AP-101

ANEPSCO, Inc.  
Division of Nuclear Safety

Attn: AP-101 Cask Submittal

Enclosed are ten (10) copies each of Section 6 CRITICALITY EVALUATION, and Section 7 OPERATING PROCEDURES, to complete ANEPSCO's submittal for a petition to amend the AP-101 cask Certificate of Compliance to include spent fuel assemblies as contents.

FIG 10. THERMAL RADIATION SHIELD ARRANGEMENT

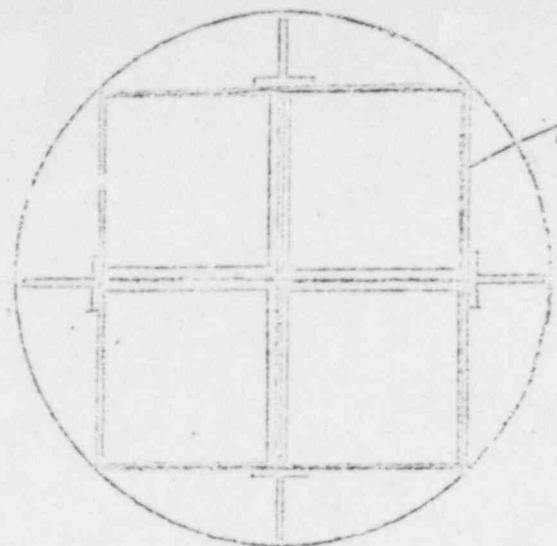
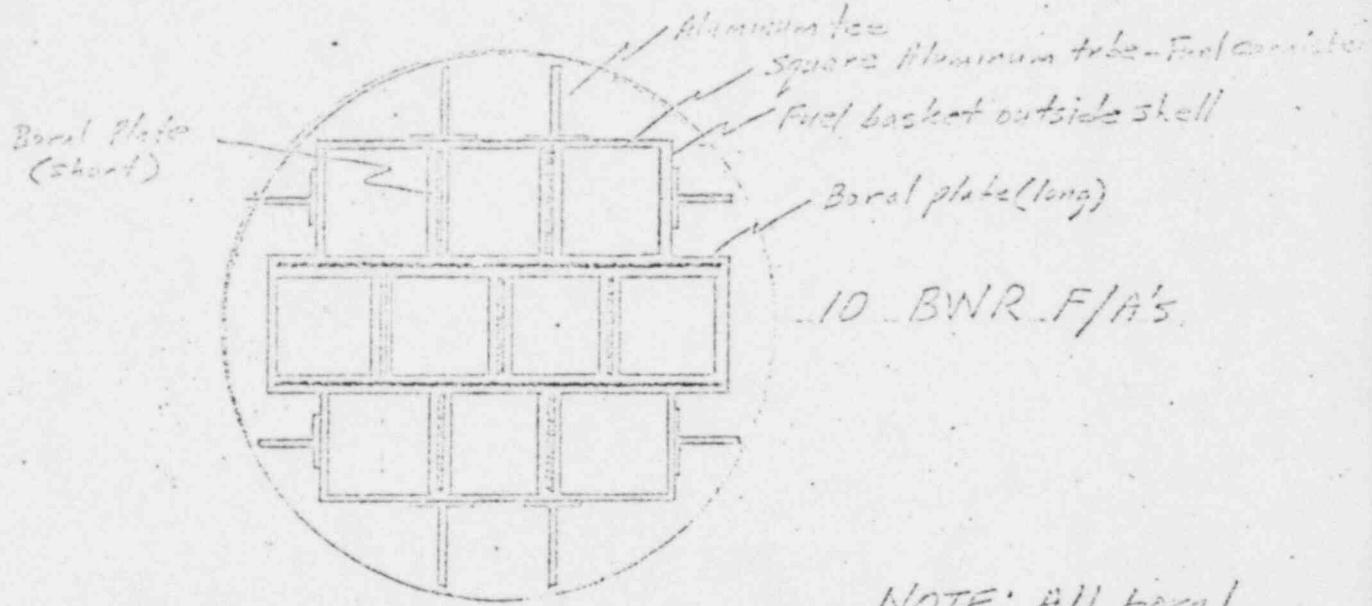
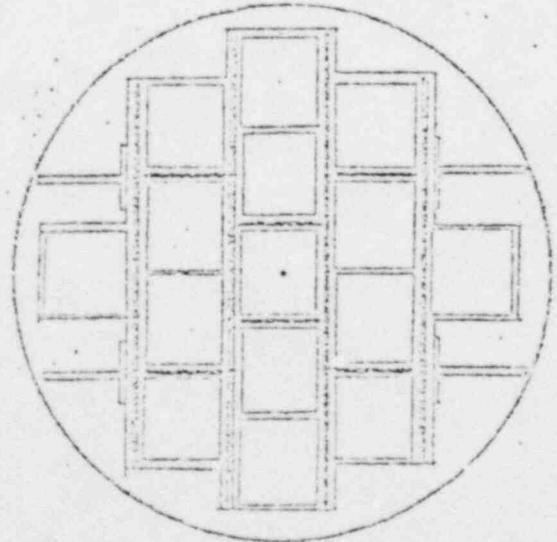
While the earlier submittal of December 20, 1979 indicated in Figure 1.6 (page 1-17) and on page 1-18 that 1/4" thick boral plates would be used for criticality control, we have added 1/8" thick plates of boral to the spent fuel basket design for PWR fuel. Revision A sheets for Figure 1.6 and page 1-18 are attached which incorporate that design modification.

$\frac{1}{8}$ " boron plates (4) (A)

NOTE: All boron plates  $\frac{1}{4}$ " thick except as noted. (A)

Boral plates of nominal 1/4" and 1/8" thickness are used in the fuel baskets to provide criticality control. As noted in Figure 1.6, none of the plates will traverse the full width of the fuel basket in order to provide a conduction path for heat transfer from interior spent fuel assemblies. The boral plates will be affixed to the fuel cannisters with flat steel bands. The long boral plates will be banded to several fuel cannister tubes. Short boral plates will be banded to a single fuel cannister.
